UNITED STATES
NUCLEAR REGULATORY COMMISSION
REGION IV
1600 EAST LAMAR BLVD
ARLINGTON, TEXAS 76011-4511

SUBJECT: SAN ONOFRE NUCLEAR GENERATING STATION – NRC AUGMENTED
INSPECTION TEAM FOLLOW-UP REPORT 05000361/2012010 AND
05000362/2012010

IR 05000361/2012010 and 05000362/2012010; 08/20/2012 - 09/28/2012; San Onofre Nuclear Generating Station; Augmented Inspection Team Follow-up Inspection.

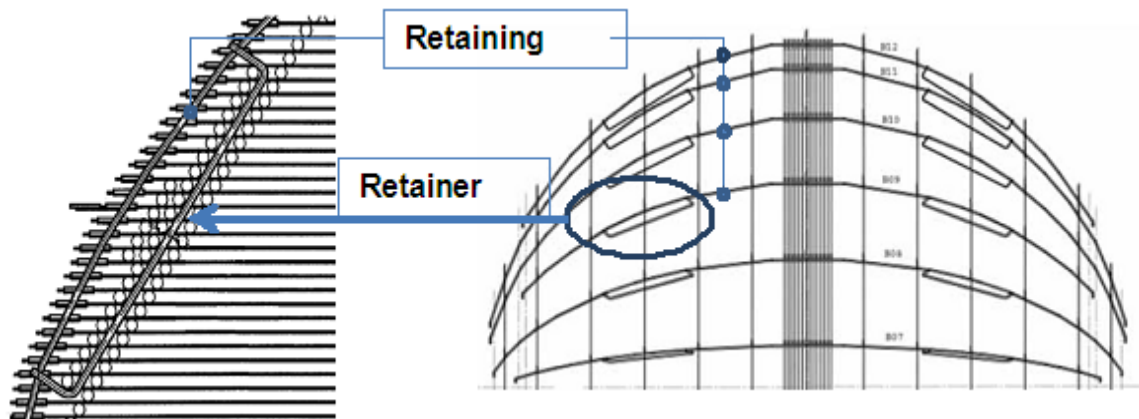
As shown in the figure below, the retainer bars are internal parts of the steam generator anti-vibration bar assembly that are attached to a series of retaining bars to capture a small group of tubes with the purpose of restraining movement of the anti-vibration bar assembly during manufacturing, upending during installation; and a main steam line break design basis event. The anti-vibration bar assembly was designed to float in between the tubes and be held in place by friction. There are 24 total retainer bars of two different diameter sizes in each steam generator. There are two groups of twelve bars where each group has six large and six small diameter bars. The different sized bars were needed to accommodate the different size of tube gaps in different areas of the bundle. Only tubes adjacent to the smaller diameter bars experienced wear indications. The retainer bars capture two short rows of tubes, which physically stop anti-vibration bar movement into or out of the tube bundle. Only those tubes immediately adjacent to both sides of the retainer bars (23 inside and 24 outside) were affected or potentially affected by vibration wear between the retainer bar and tubes. The first captured row was not affected by the retainer bar vibration.

The Cause Evaluation Report NN 201843216 identified that the mechanistic root cause of the tube-to-retainer-bar wear was due to inadequate design of the smaller diameter retainer bars in that the bar size (diameter and length) was insufficient to prevent excessive flow-induced vibration. The retainer bars were designed and fabricated with longer and smaller-diameter than previous designs, which resulted in a lower natural frequency when compared with previous configurations, increasing the susceptibility to flow-induced vibration. This resulted in tube wear from vibration contact between the retainer bars and tubes inside the steam generators. The vibration source was characterized as turbulent two-phase flow across the retainer bars.

was considered to be the most probable cause of the vibration in the smaller diameter retainer bars, based on flow forces near the retainer bars, combined with the rather low natural frequency of the retainer bar. The evaluation concluded that the cross-flow velocities in the replacement steam generators could result in large vibration amplitude of the smaller diameter retainer bars.
